**IN THE DRAWINGS:**

## REMARKS

This is intended as a full and complete response to the Office Action dated June 25, 2007, having a shortened statutory period for response set to expire on September 25, 2007. Claims 1-20 are pending in the application. By way of this reply, Applicants are amending claims 1, 9, and 16, canceling claims 6, 7, 13, 14, and 18, and adding claims 21-25.

**Fig. 5A**

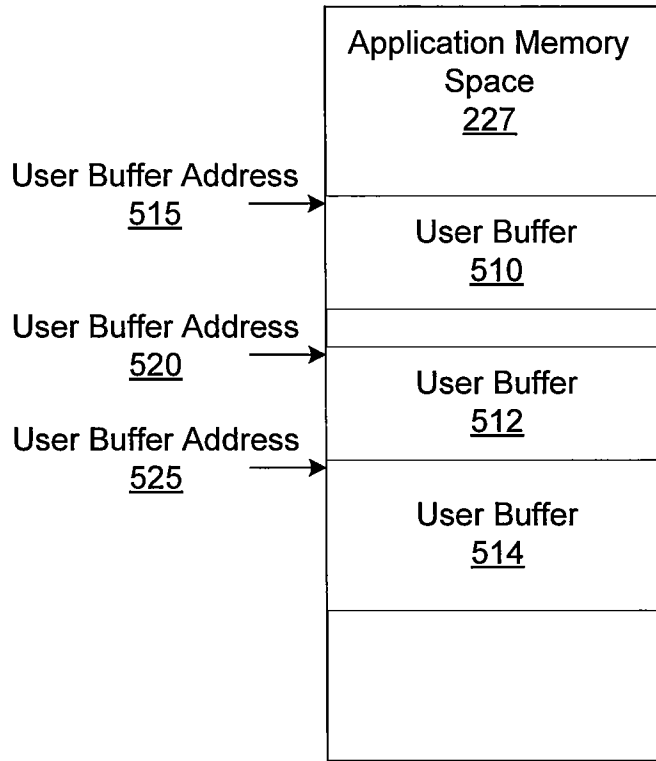
The attached sheets of drawings include changes to Figures 5A, 10A, and 10B. The first attached sheet including Figures 5A and 5B replaces the original sheet including Figures 5A and 5B. “Application Memory Space 225” in Figure 5A has been changed to “Application Memory Space 227” to match the description in paragraph [0061] of the specification. The second attached sheet including Figures 10A and 10B replaces the original sheet including Figures 10A and 10B. Figures 10A and 10B have each been amended to include text labels.
